From: Paul Cuta [REDACTED]
Sent: Wednesday, March 29, 2017 3:55 PM
To: Halvorson, Eric
Cc: Gregg Shimanski; Nathan Wautier; Lucas N. Roe; Firchow, Kevin; Eskrich, Sara
Subject: 1603 Monroe - # DriveThru Options Discussed
Attachments: 15002_2017_0329_DriveThru_COMPILED OPTS.pdf; ATT00001.htm

Drive - Thru Layout Adjustments based on 3-16-2017 Neighborhood Input

Sixteen O Three Monroe
Scale: 3/32" = 1' - 0"

Parking & Drive-Thru Option 3

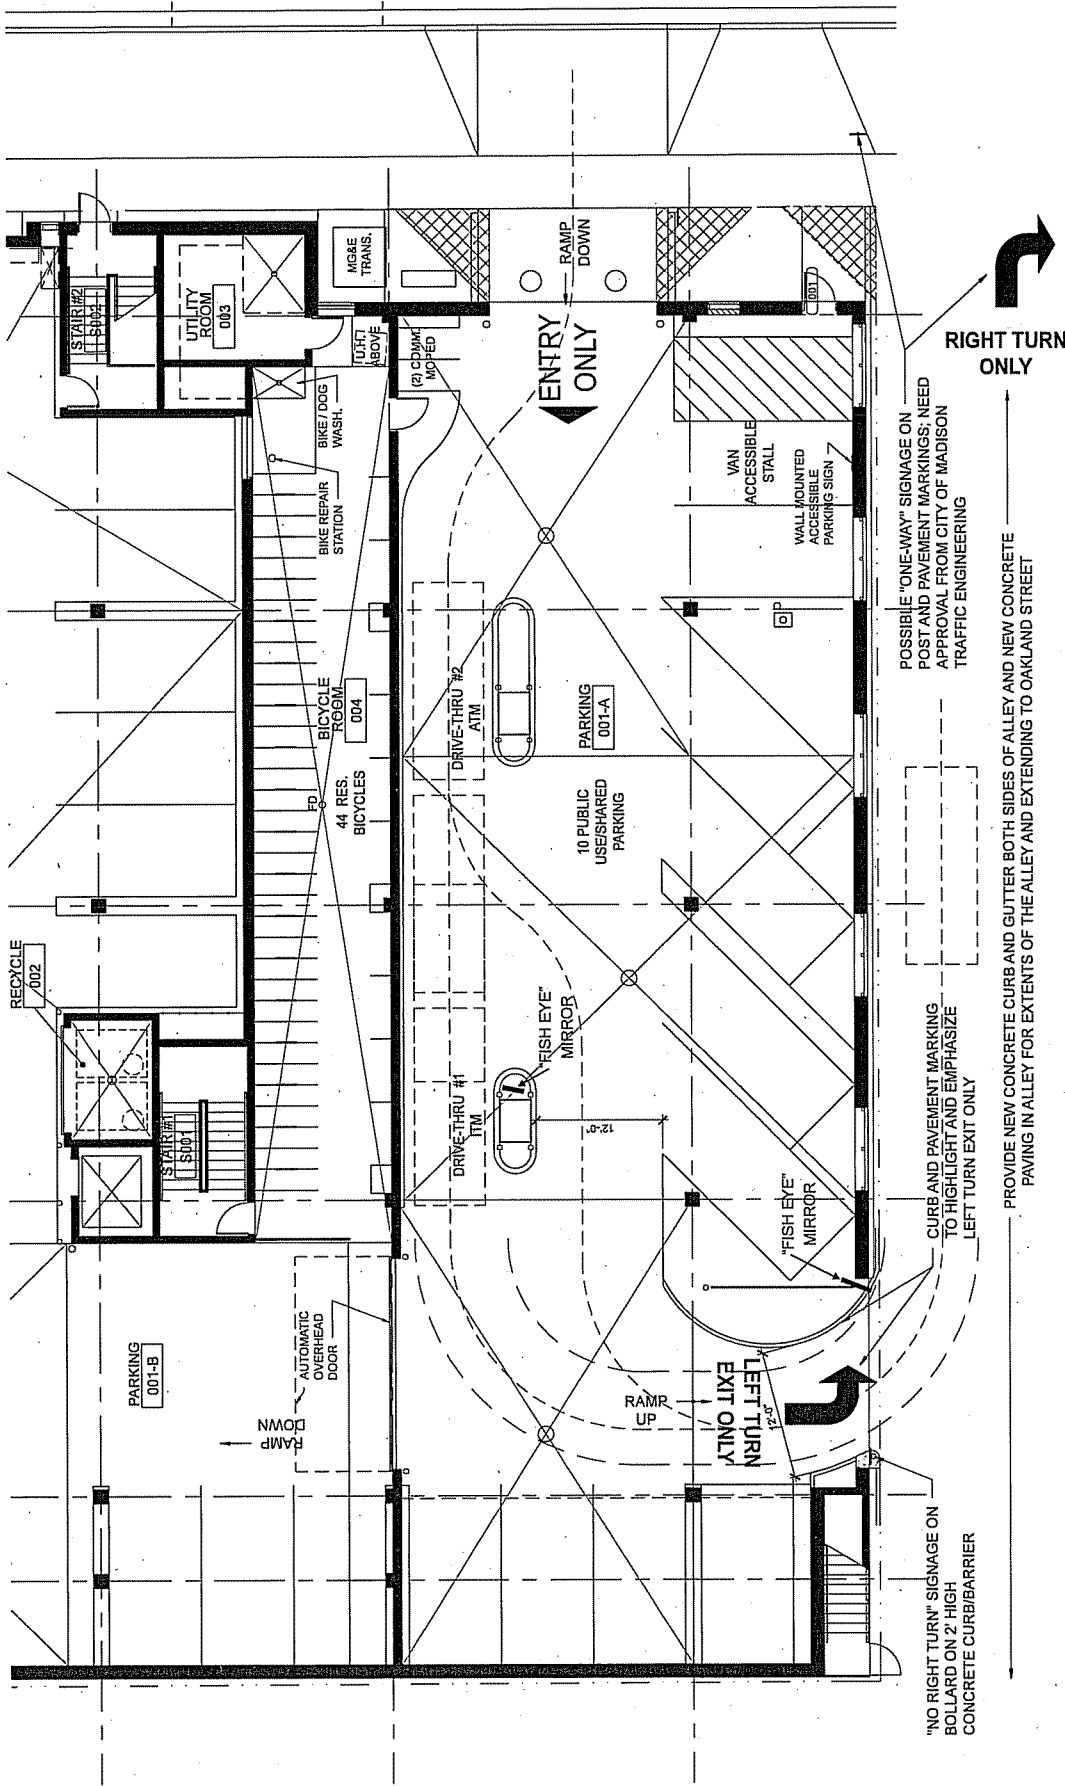
POSSIBLE "ONE-WAY" SIGNAGE ON POST AND PAVEMENT MARKINGS; NEED APPROVAL FROM CITY OF MADISON TRAFFIC ENGINEERING

CURB AND PAVEMENT MARKING TO HIGHLIGHT AND EMPHASIZE LEFT TURN EXIT ONLY

"NO RIGHT TURN" SIGNAGE ON BOLLARD ON 2' HIGH CONCRETE CURB/BARRIER

PROVIDE NEW CONCRETE CURB AND GUTTER BOTH SIDES OF ALLEY AND NEW CONCRETE PAVING IN ALLEY FOR EXTENTS OF THE ALLEY AND EXTENDING TO OAKLAND STREET

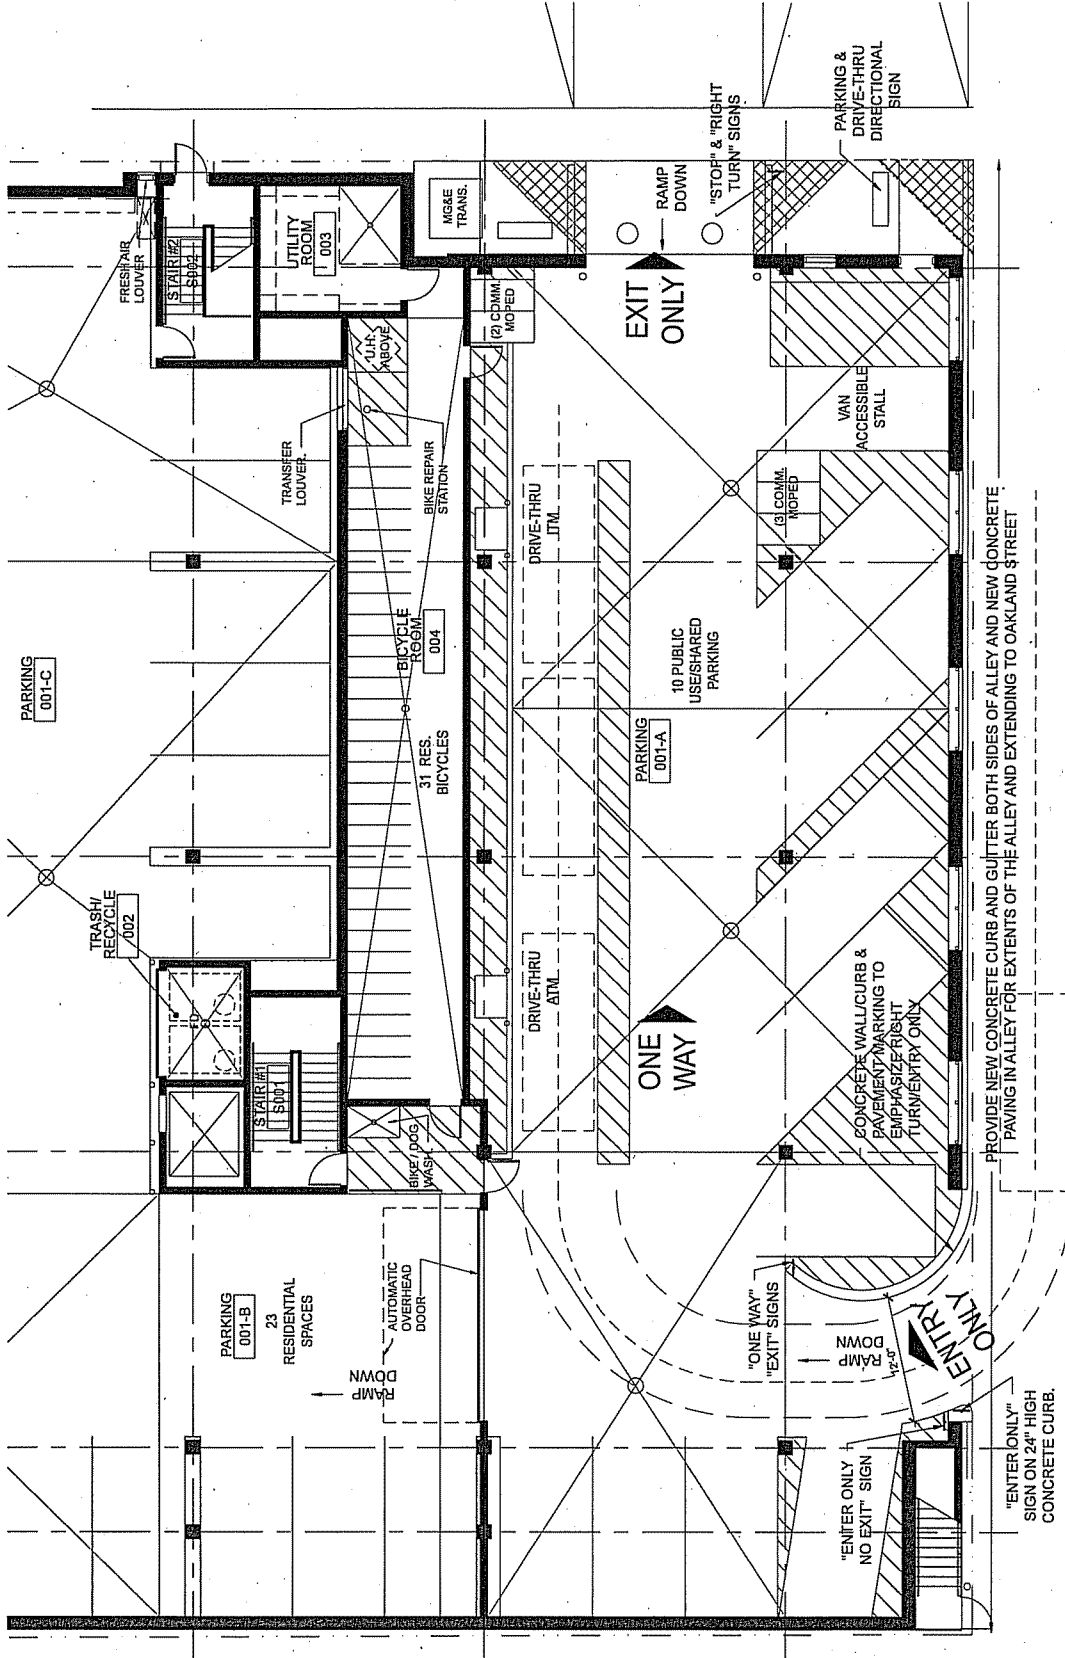
Thanks again for meeting on this a couple of times today. I've attached PDF's of the three variants we covered. As discussed, there are pro's and cons to each of these but essentially the same in concept with regard to Drive-thru or drive-up banking kiosks. Our options were derived from and tweaked to address functional and neighborhood concerns. With regard to the later, traffic flow in the alley to the west of the building was deemed most undesirable at the neighborhood meetings.
